City of Raleigh Development Plans Review Center One Exchange Plaza Raleigh, NC 27602 (919) 996-2626 www.raleighnc.gov

Case File / Name: S-2-15 / Lumley Road Development Subdivision

SUBJECT: S- 02-15, Lumley Road Development Subdivision

OFFICIAL ACTION: Approval with conditions

Proposed Preliminary Subdivision Plan

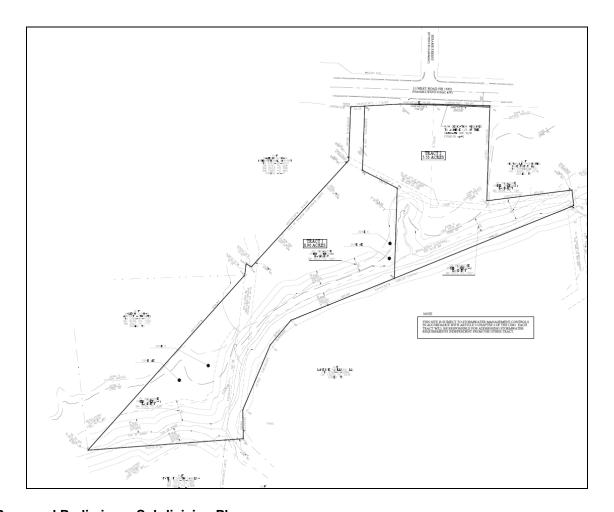
- (3) That the preliminary plan be revised and the 20' storm water drainage easement label, "Area for future drainage easement", as shown on sheet C-300, be also shown on sheet C-200, and a copy delivered to the Planning Department prior to authorization to record lots;

- (4) That a fee in lieu for a 6' sidewalk is paid along the entire frontage;
- (5) That flood prone areas, as approved by the City Stormwater Engineer, are shown on the preliminary plan and shall be shown on the recorded map;
